Docket Number:	00-AFC-14C
Project Title:	El Segundo Power Redevelopment Project Compliance
TN #:	238234
Document Title:	Staff Analysis of Petition to Amend for Turbine Uprate Activities
Description:	N/A
Filer:	Marichka Haws
Organization:	California Energy Commission
Submitter Role:	Commission Staff
Submission Date:	6/16/2021 2:22:12 PM
Docketed Date:	6/16/2021

**SUBJECT: El Segundo Energy Center (ESEC) (00-AFC-14C)
Staff Analysis of Petition to Amend for Turbine Uprate Activities**

EL SEGUNDO ENERGY CENTER (00-AFC-14C)
Petition to Amend Commission Decision
EXECUTIVE SUMMARY

EL SEGUNDO ENERGY CENTER (00-AFC-14C)
Petition to Amend – Uprate Project
AIR QUALITY, PUBLIC HEALTH, AND GREENHOUSE GASES
Wenjun Qian, Ph.D., P.E.

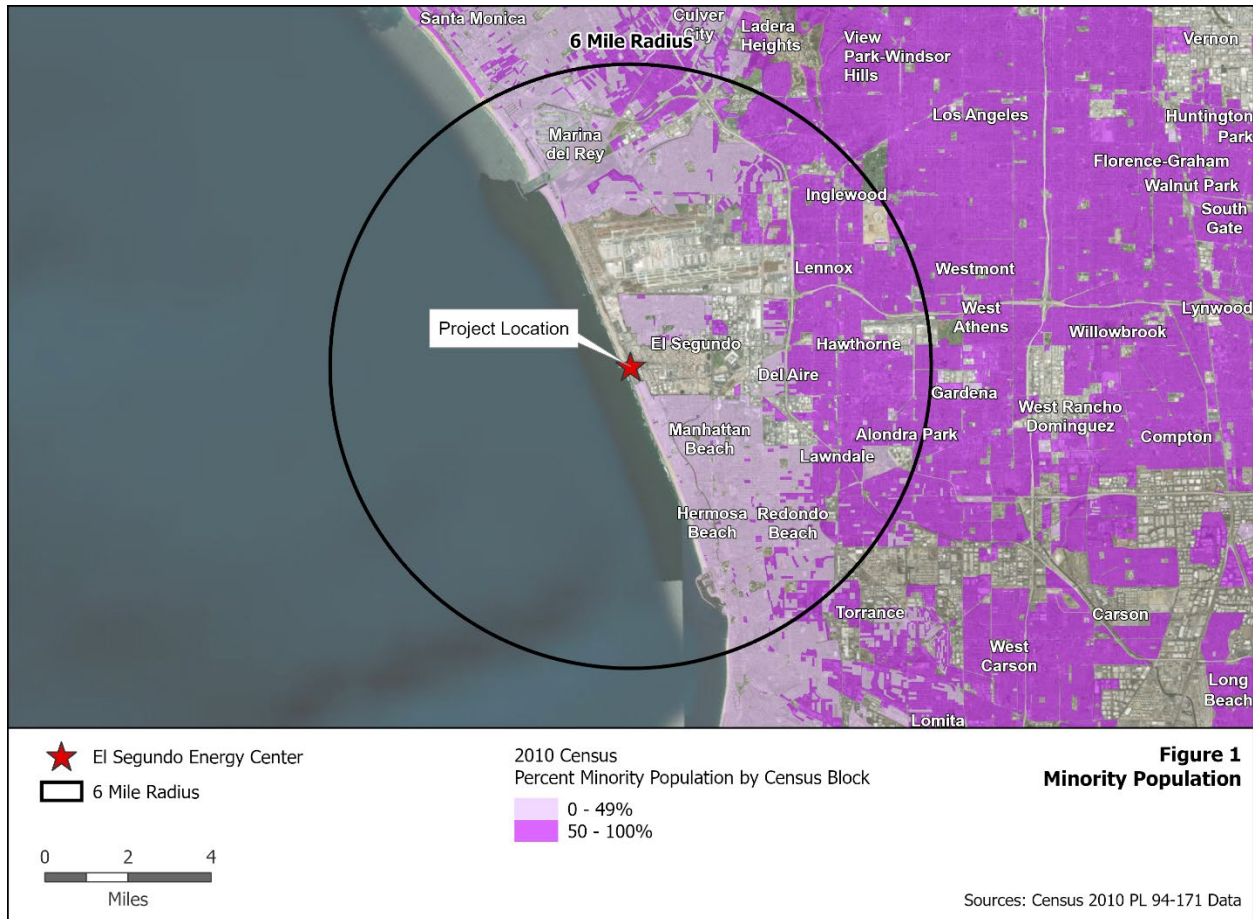
Environmental Justice – Figure 1 shows 2010 census blocks in the six-mile radius of the ESEC with a minority population greater than or equal to 50 percent. The population in these census blocks represents an environmental justice (EJ) population based on race and ethnicity as defined in the United States Environmental Protection Agency’s *Guidance on Considering Environmental Justice During the Development of*

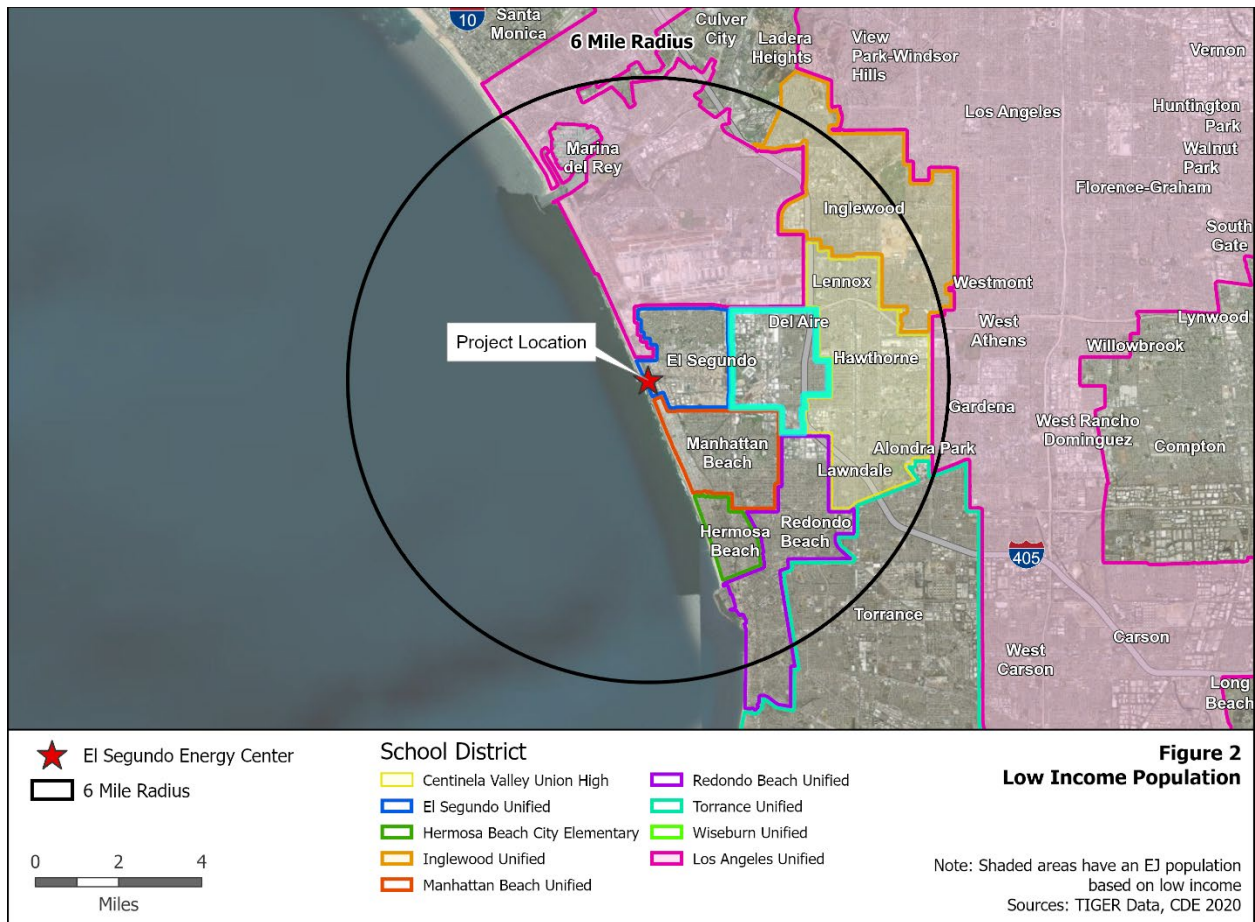
Based on California Department of Education data in the **Environmental Justice – Table 1**, staff concluded that the percentage of those living in the Centinela Valley Union, Inglewood, and Los Angeles Unified school districts (in a six-mile radius of the project site) and enrolled in the free or reduced price meal program is larger than those in the reference geography, and thus are considered an EJ population based on low income as defined in *Guidance on Considering Environmental Justice During the Development of Regulatory Actions*. **Environmental Justice – Figure 2** shows where the boundaries of the school district are in relation to the six-mile radius around the ESEC site.
